### PLANNING & ZONING DIVISION STAFF REPORT

<b>CASE NUMBER</b>	<b>PB-2014-06</b>
<b>SUBJECT</b>	Walden Lake Community Unit (CU) District
<b>APPLICANT</b>	Visions Golf LLC
<b>REQUEST TYPE</b>	Rezoning – Modification to a Community Unit (CU) or Planned Development (PD)
<b>PLANNING BOARD MEETING DATE</b>	Thursday, June 16, 2016, 6:00pm at the Trinkle Center, located at 1206 North Park Road, Plant City, Florida
<b>STAFF RECOMMENDATION</b>	Approval with the modified and additional zoning conditions noted in this staff report on the proposed revisions to the Walden Lake Community Unit (CU) District
<b>PLANNING BOARD RECOMMENDATION</b>	To be formulated by the Planning Board

**Proposed modifications to Walden Lake Community Unit District**

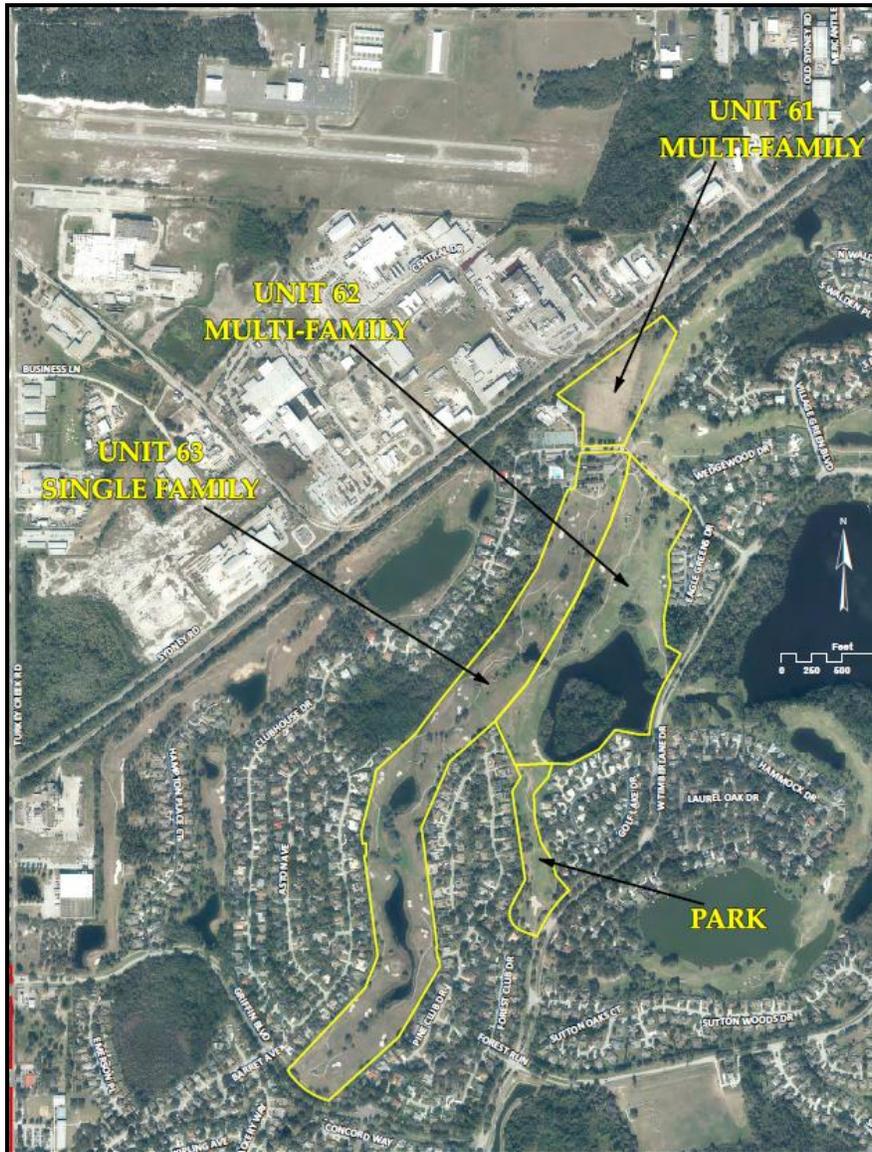
The requested single-family detached homes [Unit 63] would be located along a proposed road, which connects Clubhouse Drive and Griffin Boulevard. This new road would run generally north and south between Clubhouse Drive/Barret Avenue and Pine Club/Forrest Club Drives. Multifamily homes [Unit 62] are proposed in a pod [up to 156 Dwelling Units] that is southwest of the intersection of Clubhouse Drive and West Timberlane Drive. The applicant also proposes some additional multifamily homes [60 Dwelling Units] generally located [Unit 61] across Clubhouse Drive from the existing Walden Lake Country Club. Finally, the applicant proposes a new park along Timberlane Drive. On the following page, please reference a map depicting the locations of the proposed modifications to the Walden Lake Community Unit District and the proposed zoning conditions in Appendix B.

**Single-Family Detached Homes [Unit 63 – 61.86± Acres]**

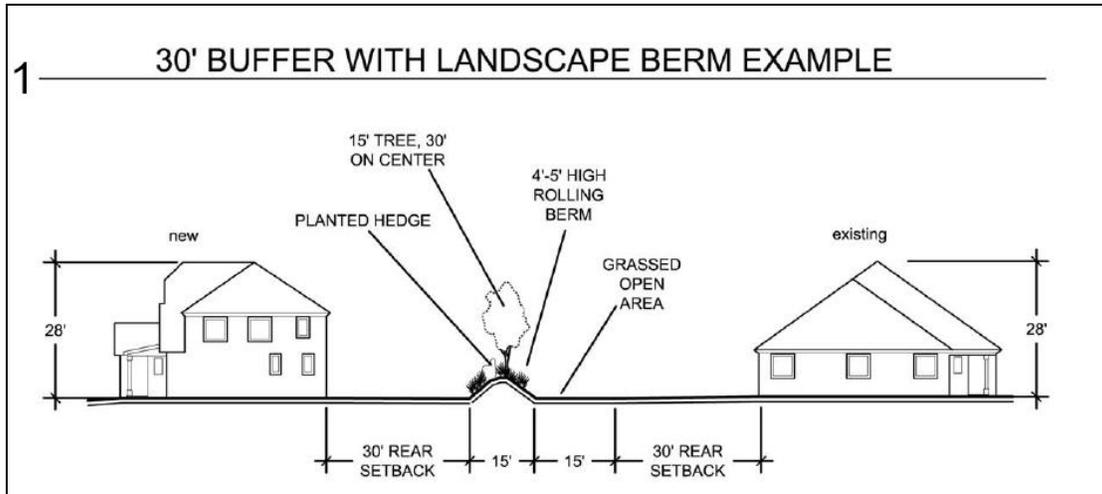
The proposed 146 single-family [2.36 du/ga] detached homes would be slightly denser than the surrounding neighborhoods in Walden Lake. Maximum height would be 28 feet and the noted setbacks [Front 25’, Rear 30’, Side Yard 10’] are consistent with the R-1A Single-Family Dwelling District. New homes would have a maximum of two livable floors and rooflines [pitched and/or gabled] would be required to reflect the residential character of Walden Lake. In addition, lots will be a minimum 85 feet wide and 10,000 square feet in Unit 63. The applicant has reduced the originally requested 154 single-family detached homes in Unit 63 that was evaluated in July 2015. The revised rezoning application, if approved, would require a separation between the new single-family homes and the adjacent neighborhoods utilizing a combination of stormwater detention/retention areas, berms, landscaping and a minimum buffer depth of 30’. Two typical cross sections [on the next page] of these buffers are shown as Example #1 and #2. Due the presence of a wetland and significant vegetation an additional buffer is not proposed between the planned new homes and Clubhouse Woods [Unit 28]. These buffers would be maintained by the new development’s homeowners association [HOA].

Staff finds the proposed development pattern, building form and buffering for Unit 63 to be compatible and in character with the adjacent neighborhoods, which are exclusively single-family detached homes that include Clubhouse Woods [1.77 du/ga], Aston Woods [2.07 du/ga] and Forest Club [2.03 du/ga].
